MANUFACTURED HOUSING CONSENSUS COMMITTEE

DRAFT MINUTES MHCC MEETING

DRAFT MINUTES MANUFACTURED HOUSING CONSENSUS COMMITTEE (MHCC) MEETING

October 18-20, 2022 & November 15-17, 2022

IMPACT DUE TO DOE PROPOSED MULTI WIDE – BOX SIZE 27x56

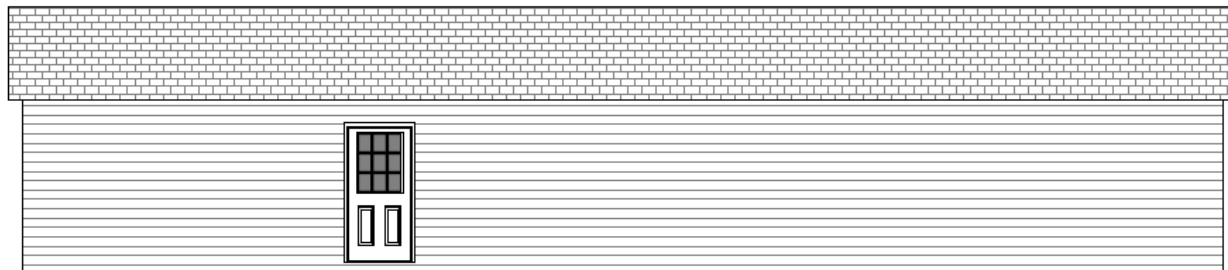
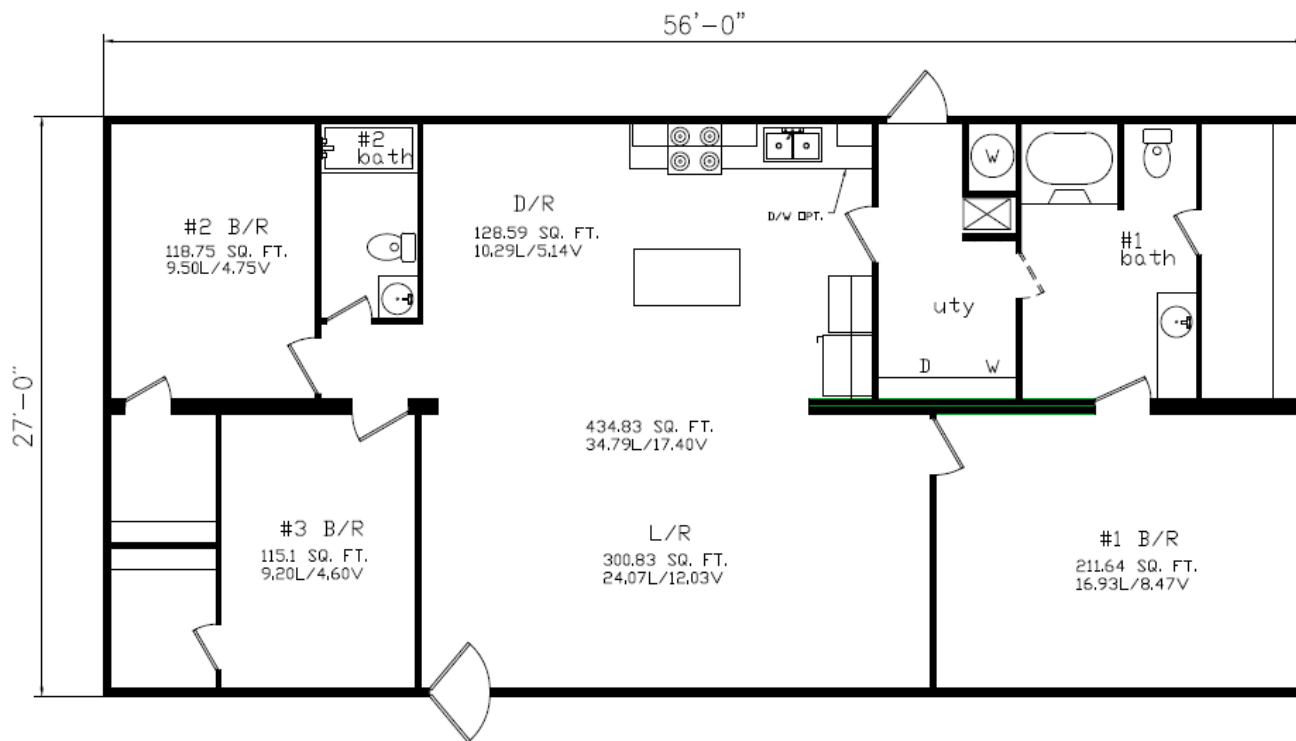
PROPOSED ZONE 3 CONSTRUCTION
INSULATION – 33 FLOOR / 15 WALL / 28 CEILING
2x4 WALLS
2x6 FLOOR JOISTS
ZERO WINDOWS
WINDOW U-VALUE = 0.32

IMPACT DUE TO DOE PROPOSED MULTI WIDE – BOX SIZE 27x56

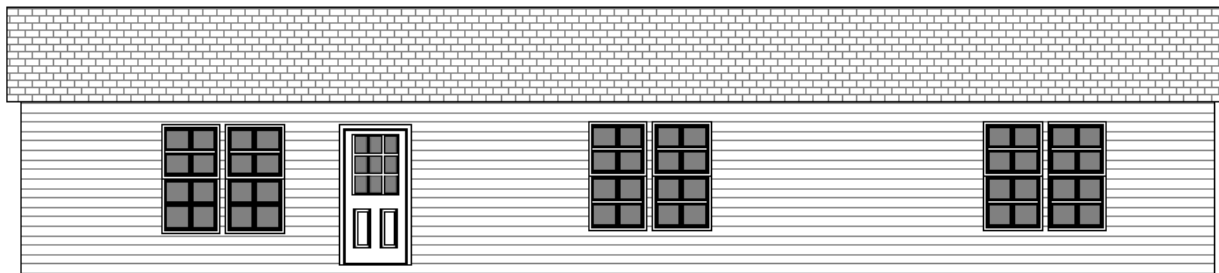
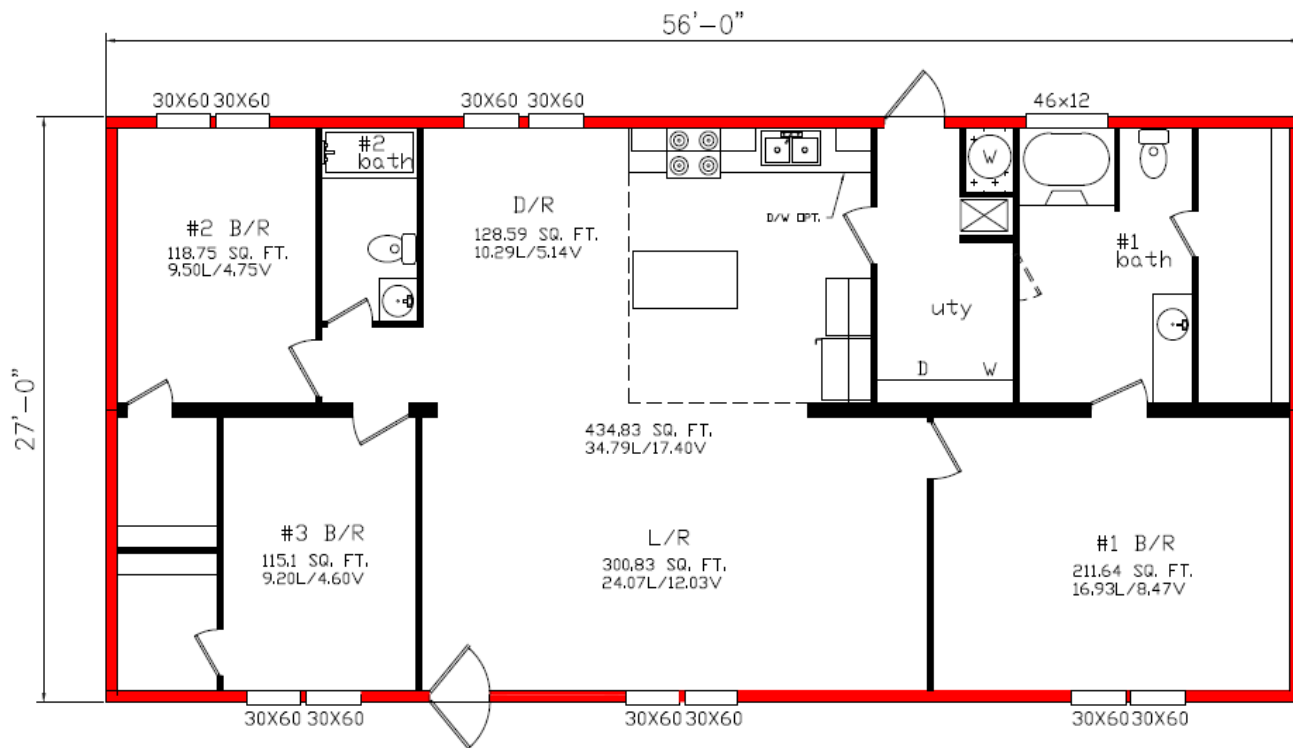
HEATED AREA – 1430 SQUARE FEET

PROPOSED ZONE 3 CONSTRUCTION

NOTES:

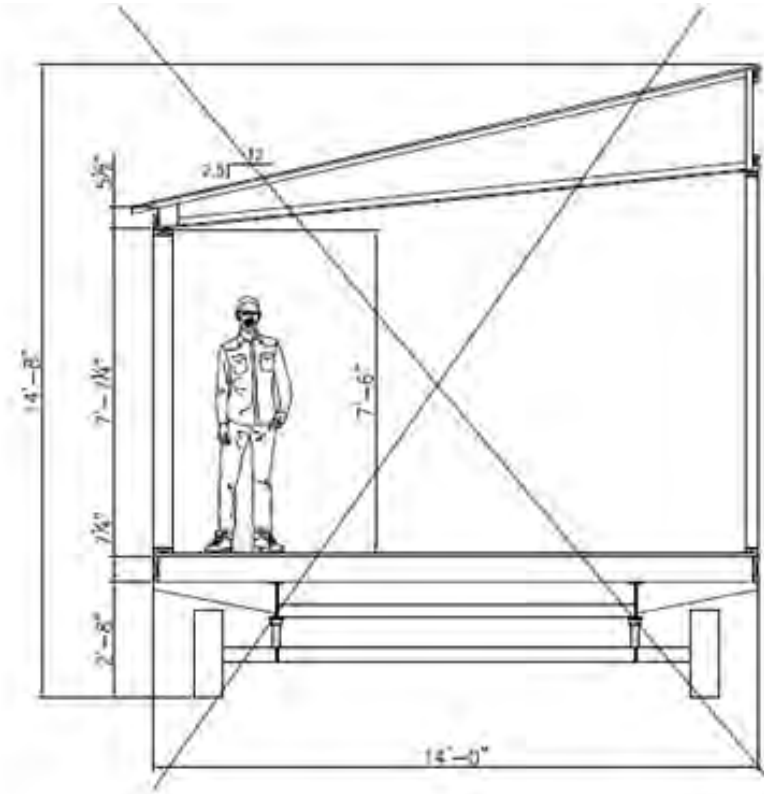
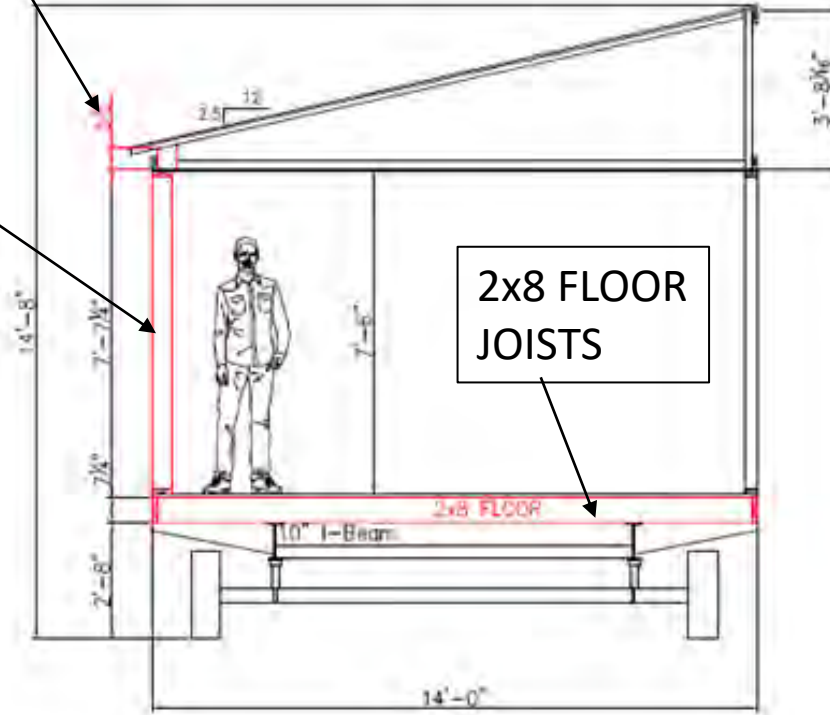
- IN ORDER TO REACH THE REQUIRED U-VALUE (0.055) THE FLOORS WERE CHANGED TO 2x8 , THE WALLS WERE CHANGED TO 2x6 AND THE INSULATION PACKAGE WAS CHANGED TO THE VALUES LISTED IN THE PRESCRIPTIVE SECTION OF THE PROPOSED CODE. HOWEVER, IT WILL BE VERY DIFFICULT TO BUILD THE HOME WITH THIS INSULATION PACKAGE USING CURRENTLY AVAILABLE MATERIALS.

- HEATED AND COOLED INTERIOR SPACE REDUCED BY 27 SQUARE FEET DUE TO THE INCREASED WALL THICKNESS.
- R-30 IN THE FLOOR WILL REQUIRE BATT INSULATION TO BE INSTALLED BETWEEN THE FLOOR JOISTS COMBINED WITH A BLANKET BELOW THE JOISTS. CURRENTLY, MOST MANUFACTURER'S DO NOT USE THIS FLOOR INSULATION TECHNIQUE.

NOTES:

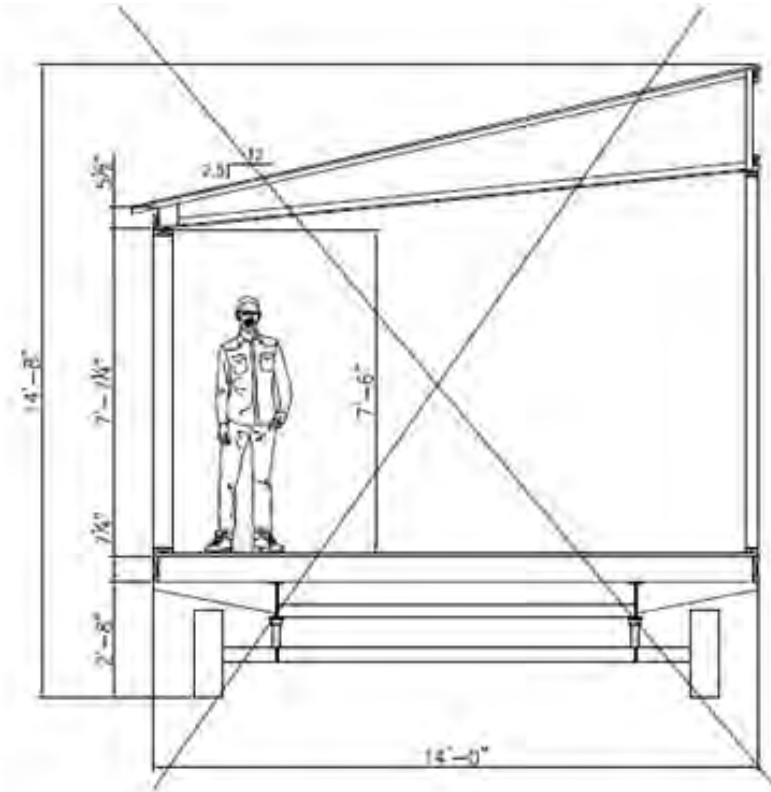
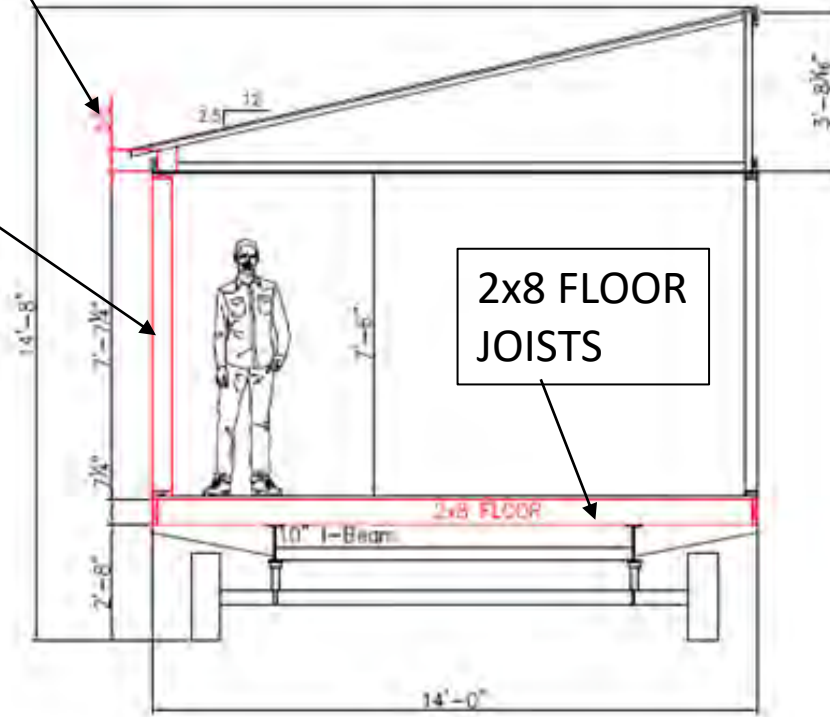
- IN ORDER TO REACH THE REQUIRED U-VALUE (0.055) THE FLOORS WERE CHANGED TO 2x8, THE WALLS WERE CHANGED TO 2x6 AND THE INSULATION PACKAGE WAS CHANGED TO THE VALUES LISTED IN THE PRESCRIPTIVE SECTION OF THE PROPOSED CODE. HOWEVER, IT WILL BE VERY DIFFICULT TO BUILD THE HOME WITH THIS INSULATION PACKAGE USING CURRENTLY AVAILABLE MATERIALS.

- HEATED AND COOLED INTERIOR SPACE REDUCED BY 27 SQUARE FEET DUE TO THE INCREASED WALL THICKNESS.
- R-30 IN THE FLOOR WILL REQUIRE BATT INSULATION TO BE INSTALLED BETWEEN THE FLOOR JOISTS COMBINED WITH A BLANKET BELOW THE JOISTS. CURRENTLY, MOST MANUFACTURER'S DO NOT USE THIS FLOOR INSULATION TECHNIQUE.
